DESIGN REVIEW COMMITTEE

October 18, 2023 6:00 PM

4.I. 3034 Springdale Road Townhome Revisions

**DEPARTMENT OF PLANNING AND ZONING
PLANNER'S REPORT**

BUILDING #9 PLANS - LOTS 45-50

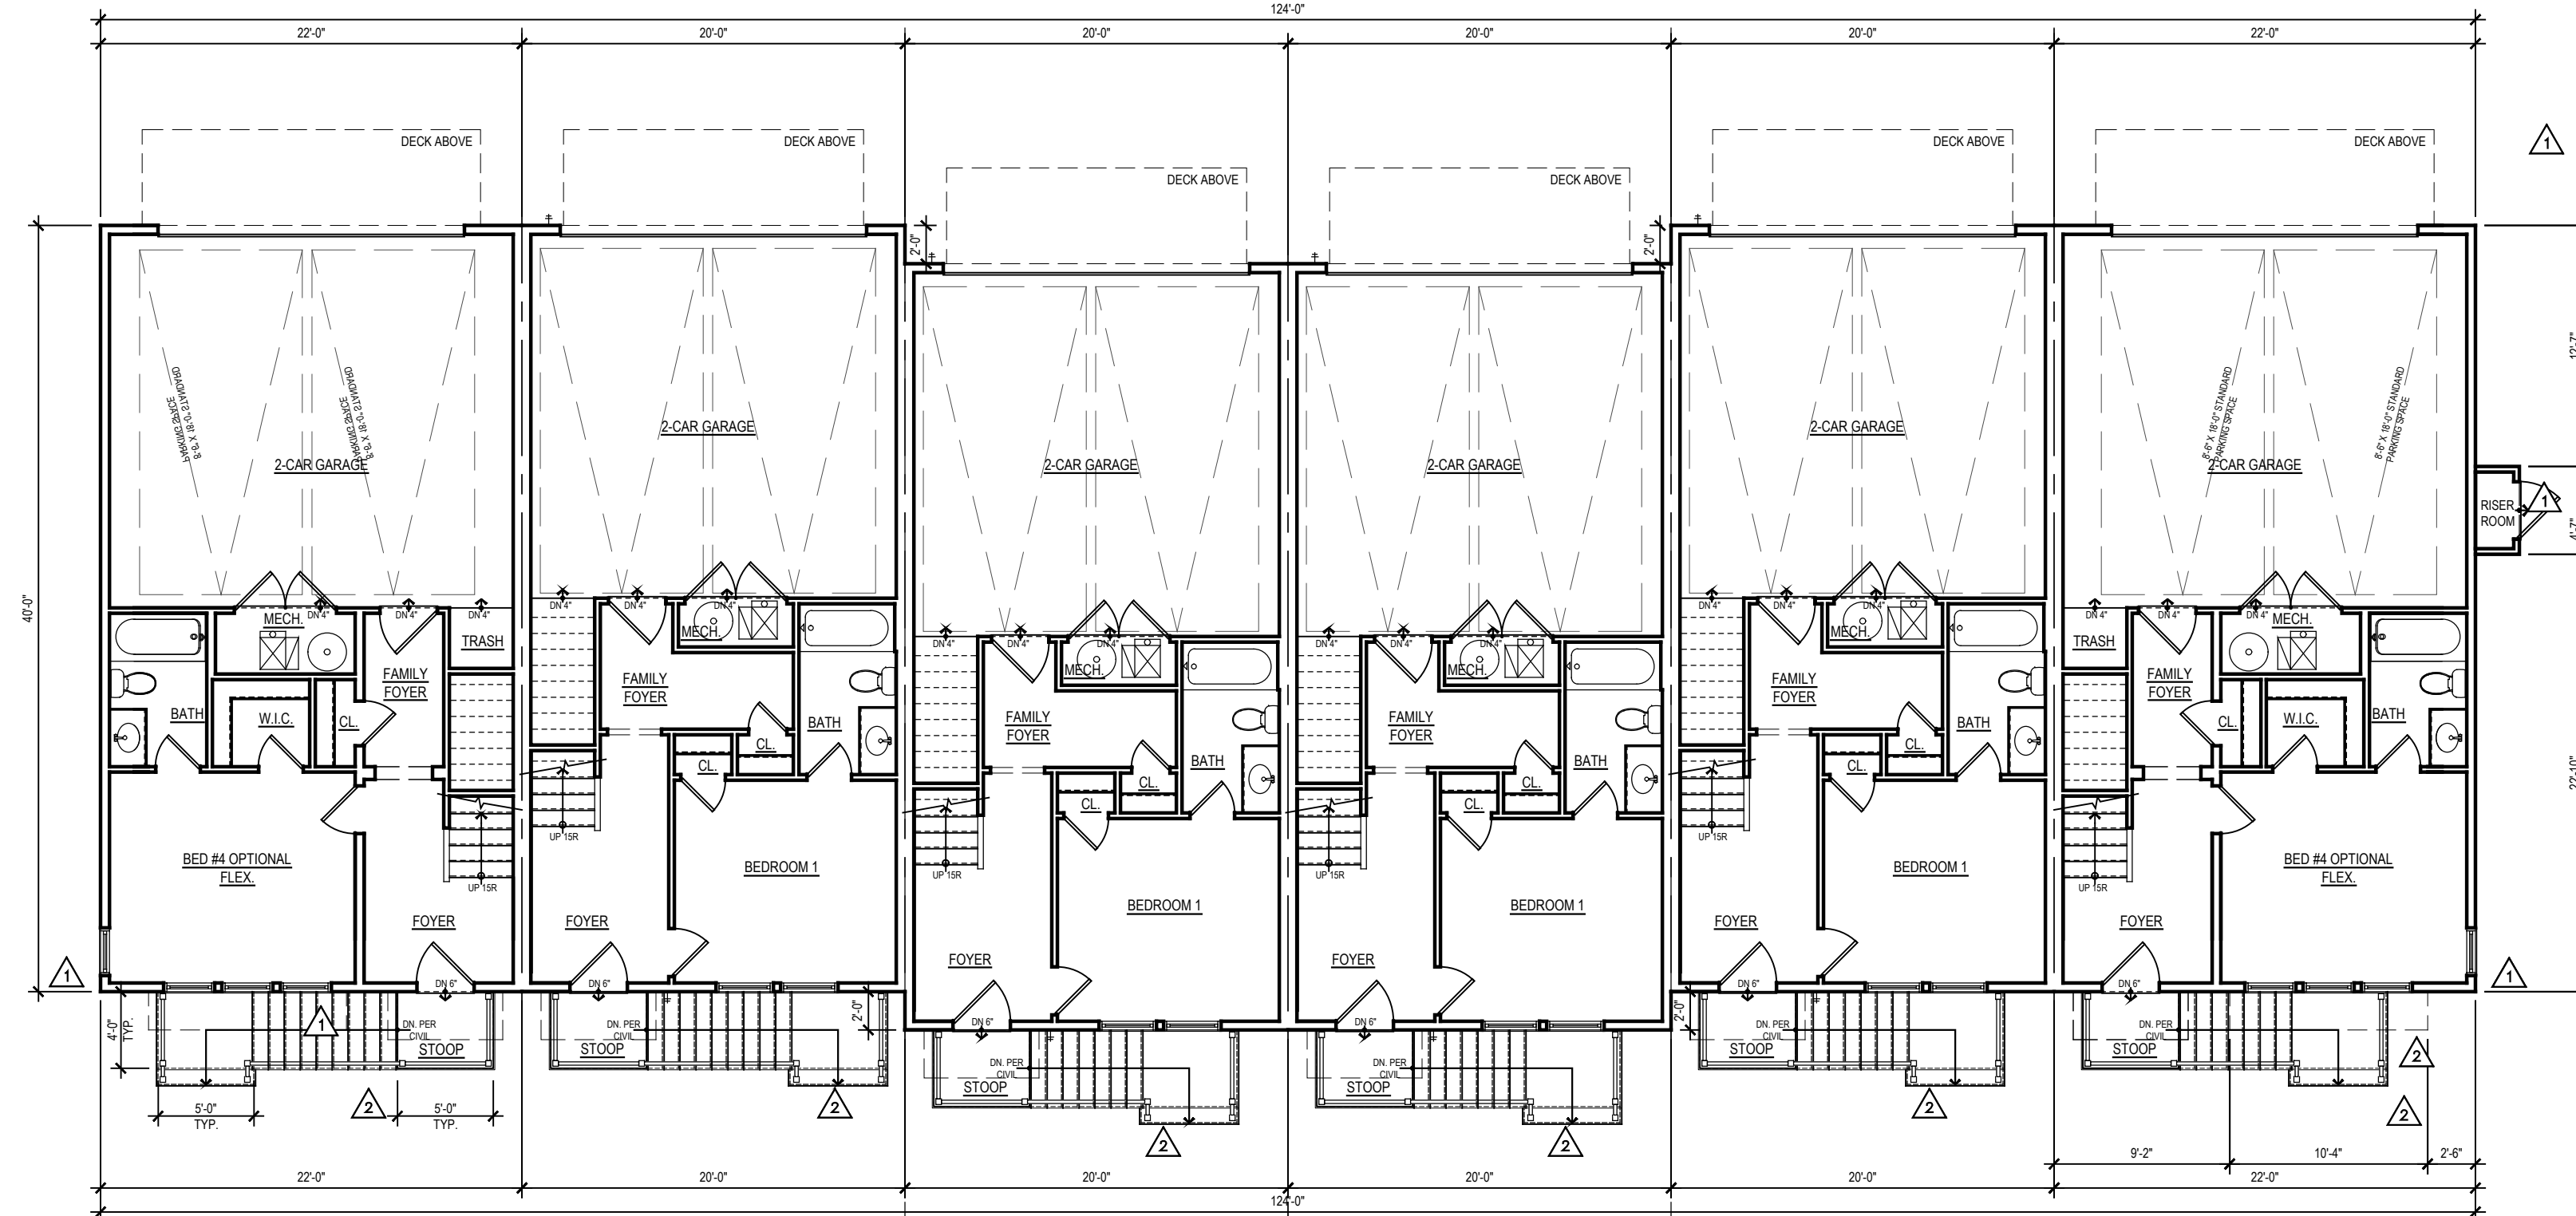
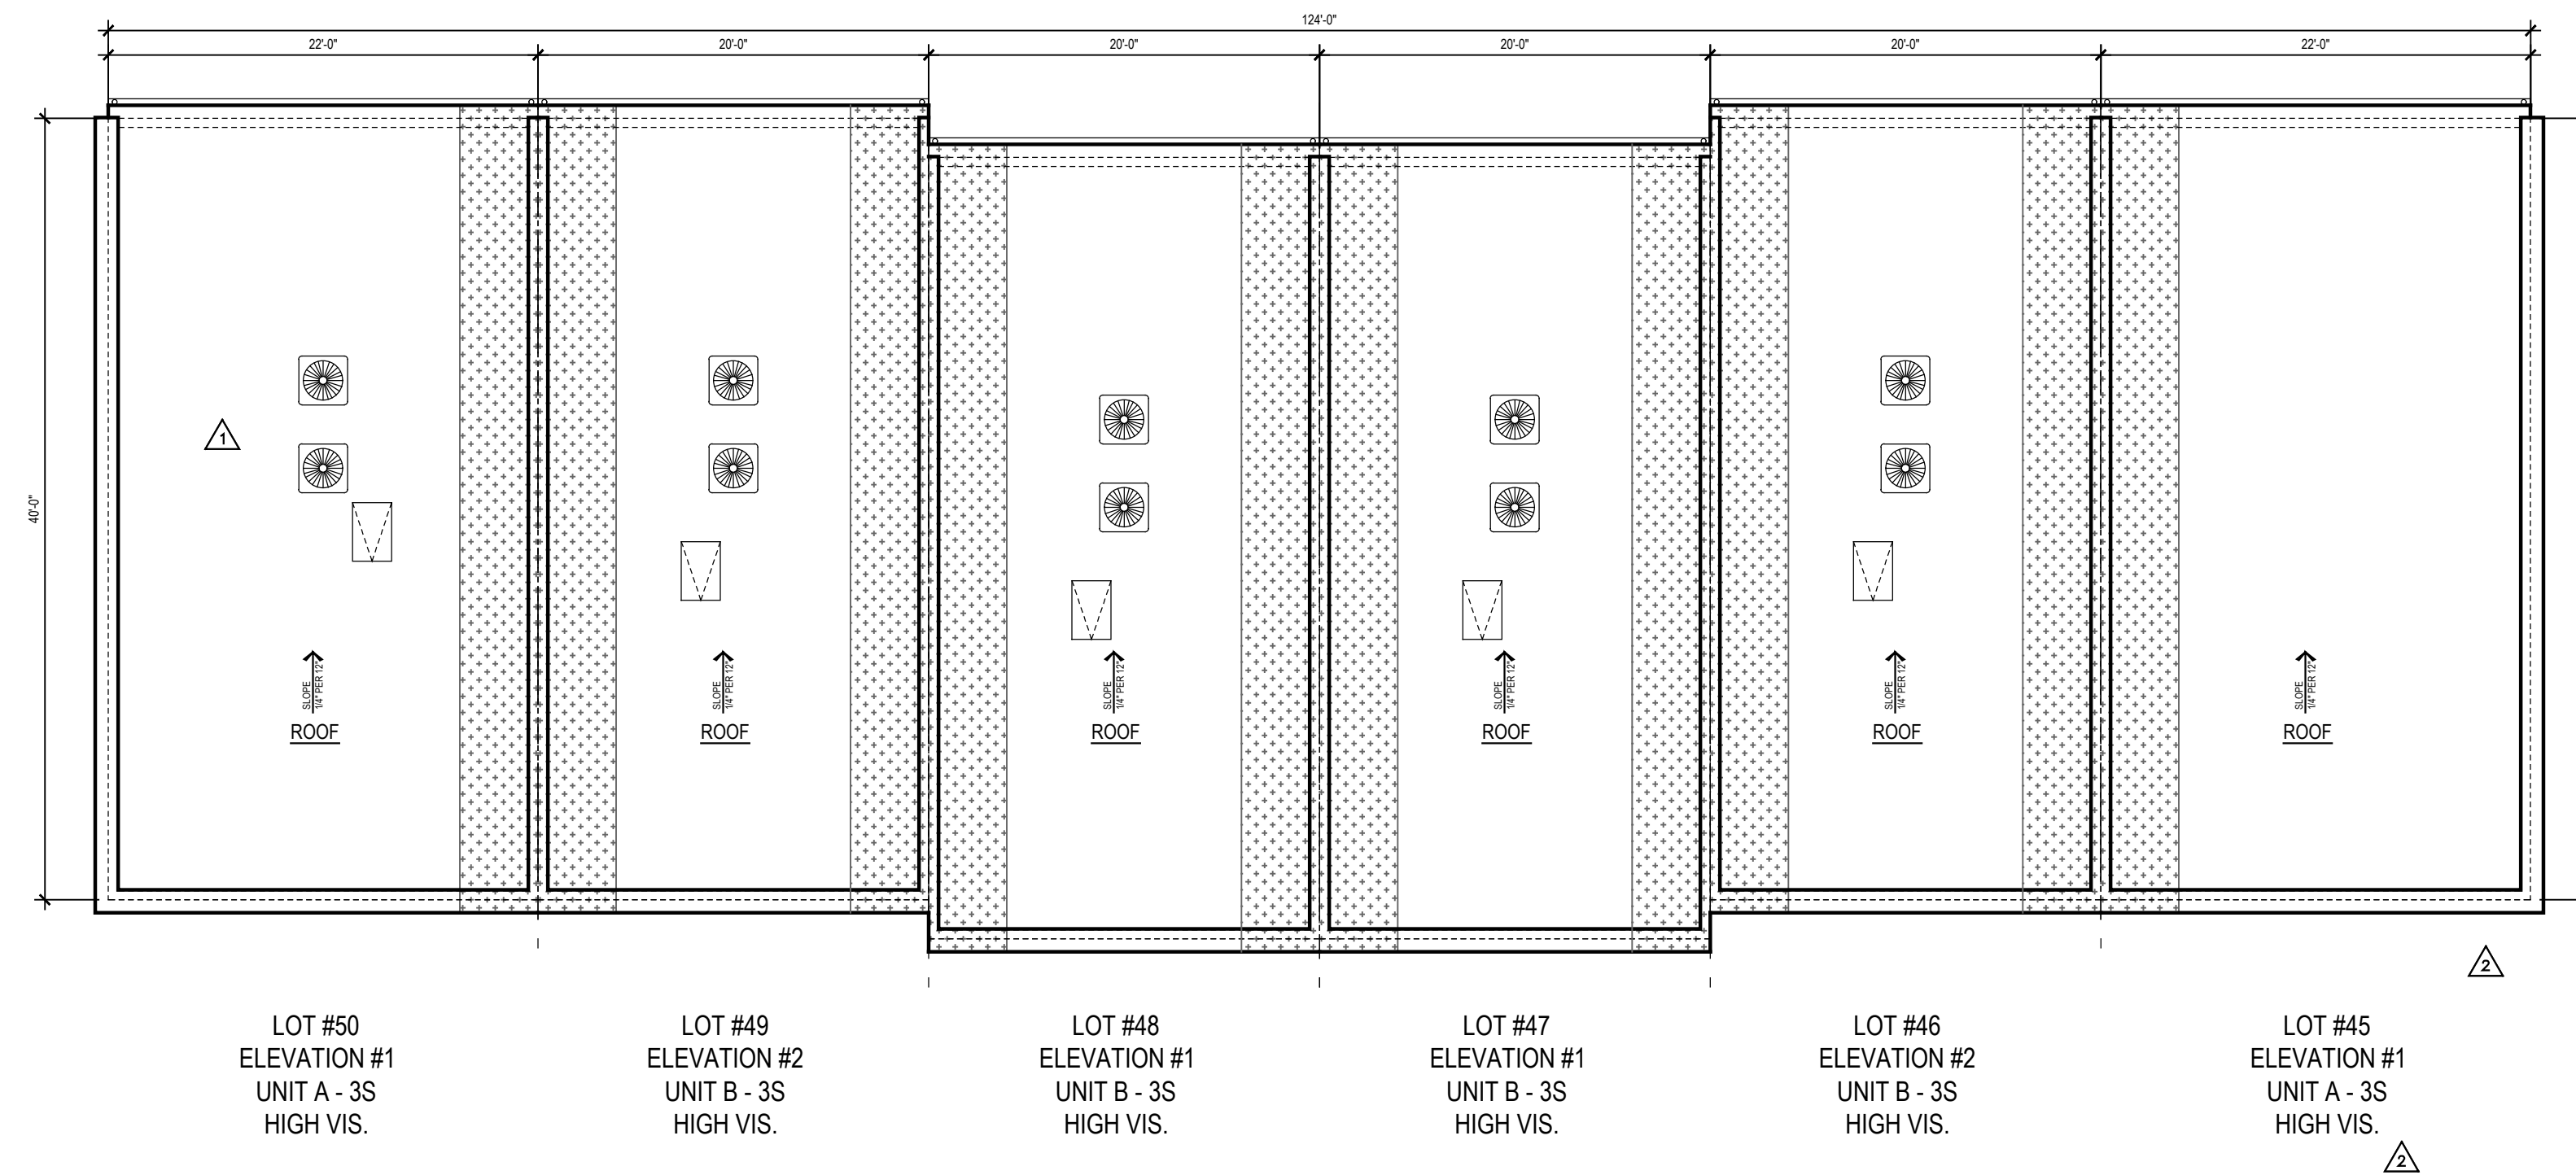
3. Lot 45 @ Building 09 was updated with Elevation A1 in lieu of A2. After. After coordinating with the latest grading plan, we noticed that the previous elevation A2 with the bay at the front was not compatible with the latest front topography.
